B 28/07/22 details of the refurbishment revised RS

CLIENT  
**MR. D. ISLIP**  
 PROJECT  
**PROPOSED REPAIRS AND WORKS TO OUTBUILDING AT HILDA COTTAGE SHELL HILL, ROBIN HOODS BAY**  
 TITLE  
**SCHEME DRAWING PLANS & ELEVATIONS**

DWG NO. 955-01 REV B DRN RS  
 SCALE 1/50 & 1/100 @ A1 DATE MAY 2022

Proposed Front Elevation

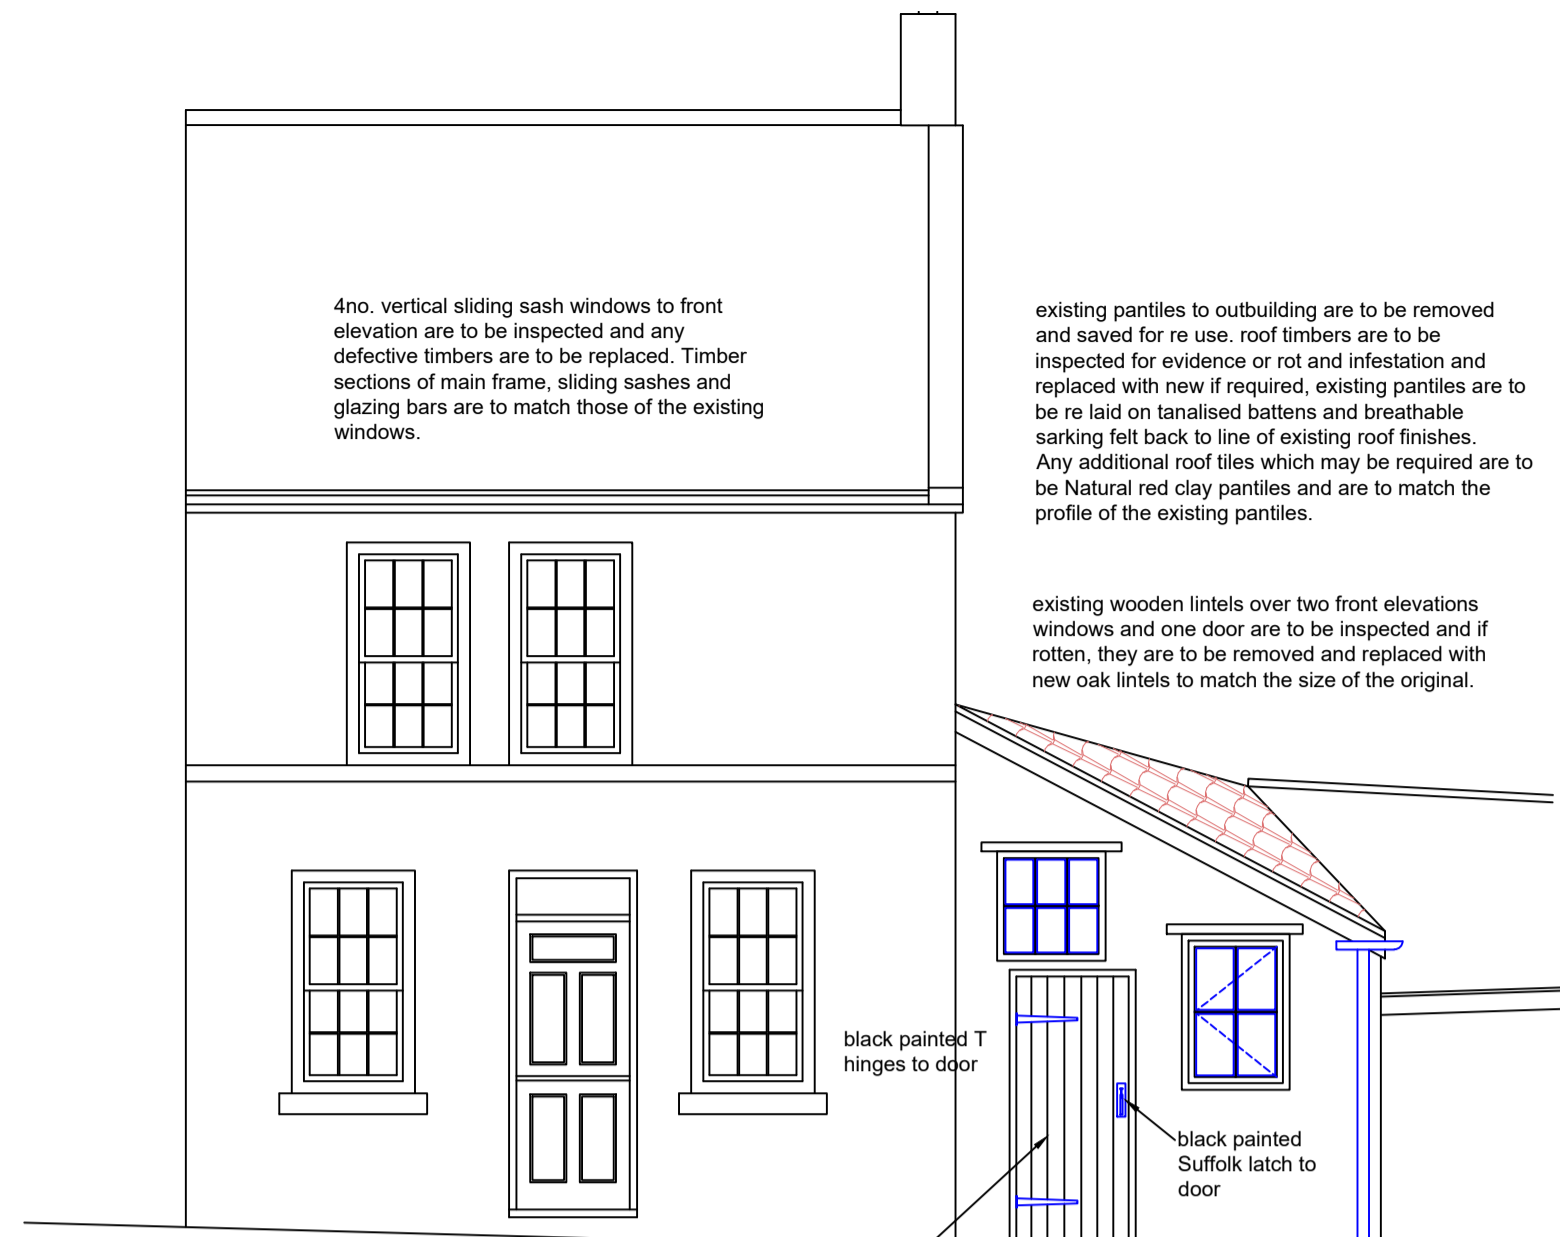
- Conservation revisions and confirmations:
- Where possible, all existing doors and windows should be repaired rather than replaced. However, it is felt that the existing windows to the dormers are beyond repair and do require to be replaced with new timber windows. Timber sections are to be as detailed. Note that all new glazing is to be single glazed.

- The windows to the store have been revised to suit the timber sections proposed on the detailing.
  - the proposed ironmongery to the replacement door has been shown and also the proposed timber sections for the door and frame.

- Any additional pantries which may be required to complete the repairs to the store roof, must be of red natural clay pantries and of a profile to match that of the existing roof tile.

- It is proposed to remove the existing paint finish from the front elevation of the store and to allow the stonework to dry out, wherupon it's condition is to be evaluated and repointing with a lime based mortar is to be carried out.

1no. timber window to side gable elevation is to be removed and new timber window is to be manufactured to suit size of external opening and inserted. Timber sections of main frame, opening sash and glazing bars are to match those of the existing window. Glazing is to be single glazed to maintain appearance of original windows.

4no. vertical sliding sash windows to front elevation are to be inspected and any defective timbers are to be replaced. Timber sections of main frame, sliding sashes and glazing bars are to match those of the existing windows.

2no. timber windows to front elevation are to be removed and new timber windows are to be manufactured to suit sizes of external openings and inserted. Timber sections of main frame, opening sashes and glazing bars are to match those of the existing windows. Glazing is to be single glazed to maintain appearance of original windows.

existing rotten door and frame to front elevation of outbuilding is to be removed, new door and frame is to be manufactured and inserted into the existing opening but secured in the closed position as a false door. details of door and frame to match those of the original door

existing rainwater pipe and gutter are to be replaced with new cast iron to match the size and profile of the existing and are to be black gloss painted with Weathershield paint

Proposed Section

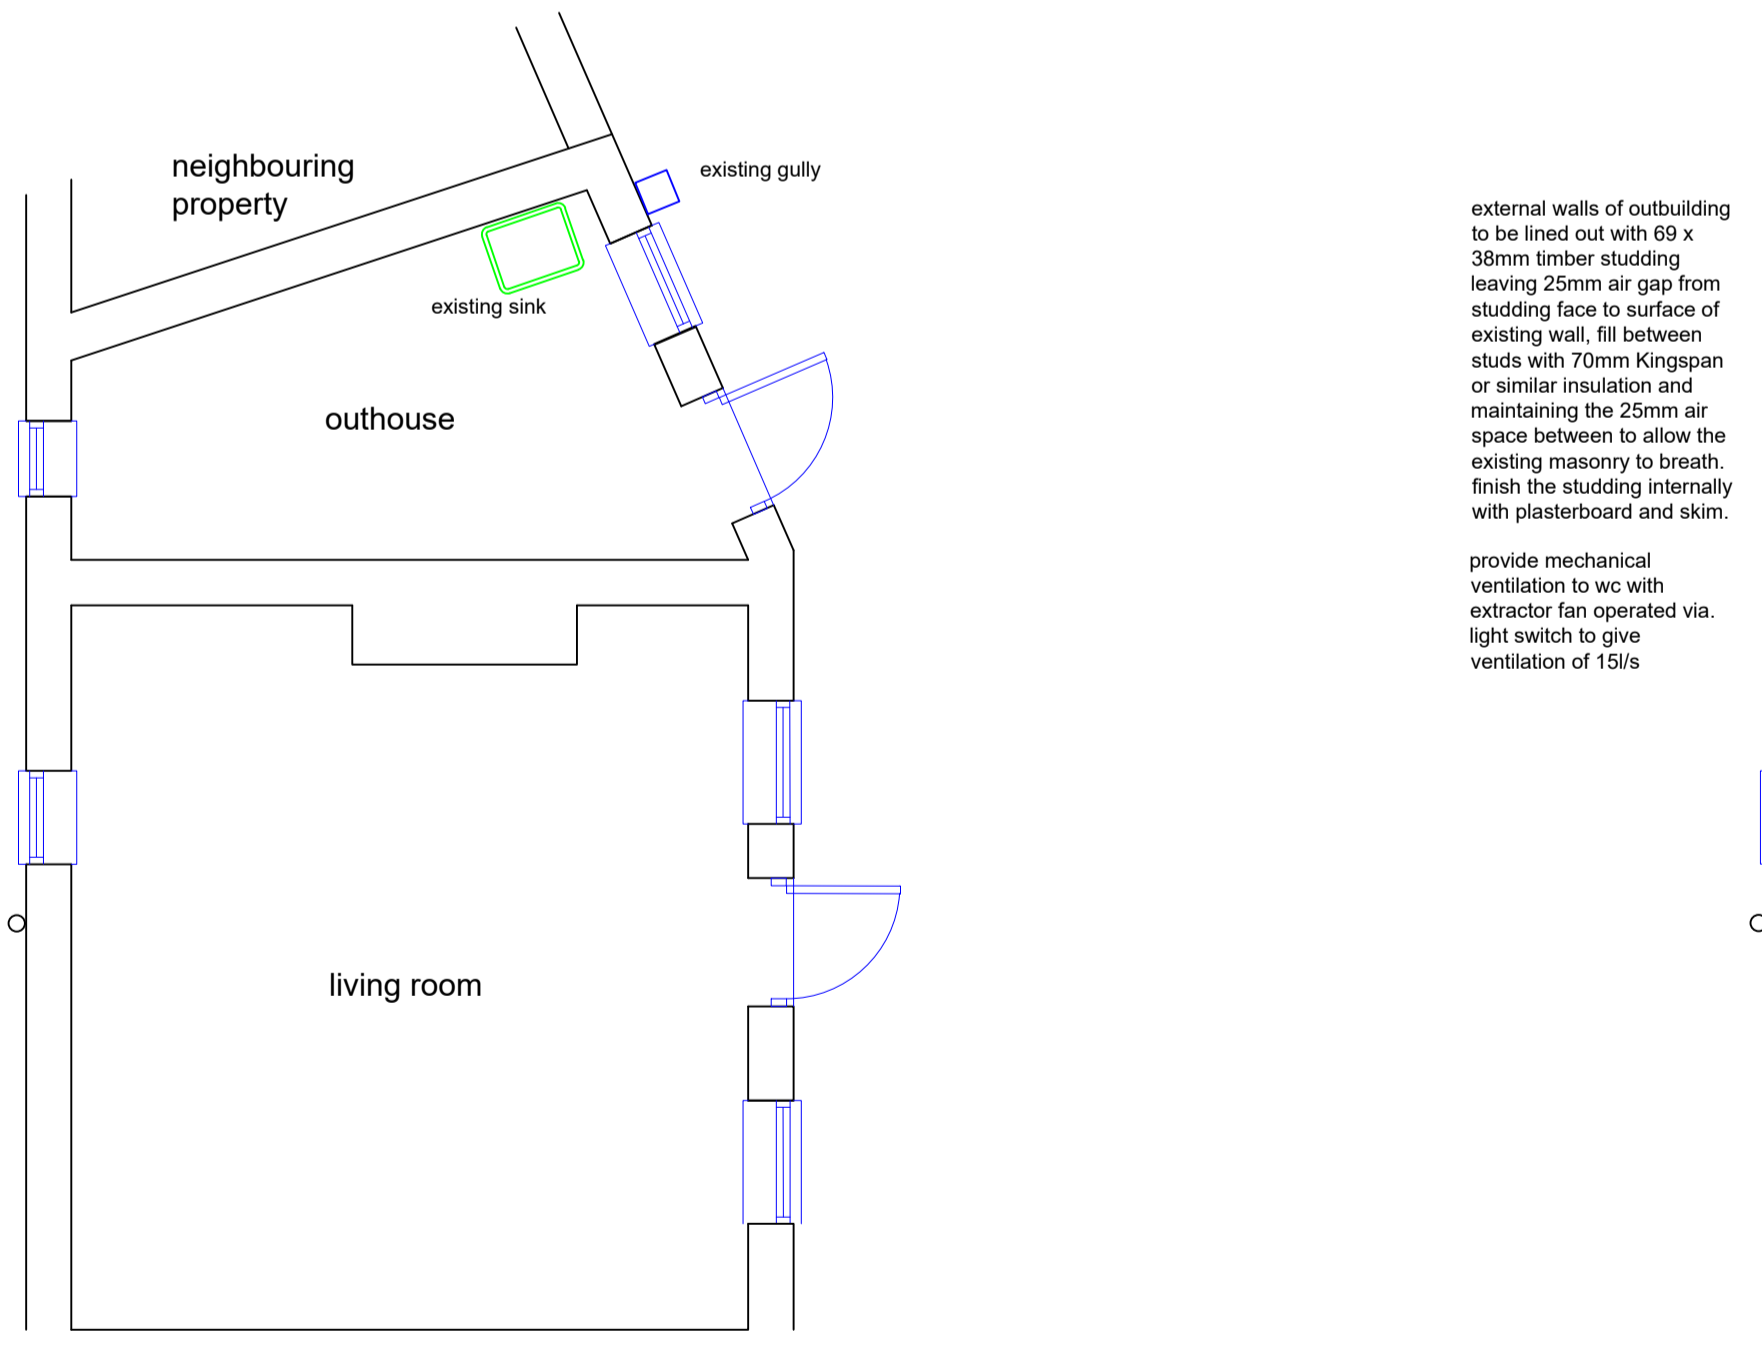
- the proposed flooring has been revised to allow for the existing floor to remain and to be finished above the existing surface with a timber floating floor.

- the proposed roof insulation has been revised to be sheeps wool insulation.
  - the rainwater goods to the rear elevation have been noted as being removed and replaced with new cast iron and to receive a black gloss painted finish.

underside of rafters to be counter battens with 50mm battens and finished with 12mm plasterboard and skim. provide 50mm sheep's wool or similar breathable natural insulation material between counter battens and ditto between rafters

existing pantries to outbuilding are to be removed and saved for re use. roof timbers are to be inspected for evidence of rot and infestation and replaced with new if required, existing pantries are to be re laid on tanalised battens and breathable sarking felt back to line of existing roof finishes.

remove debris from within outbuilding including any deleterious material and lay new 25mm t kg boarding floor finish onto new timber battens as a floating floor all laid on 1200g polythene dpm dressed up at edges to floor level. provide breathable thermal insulation between battens to suit depth required to bring to floor level.
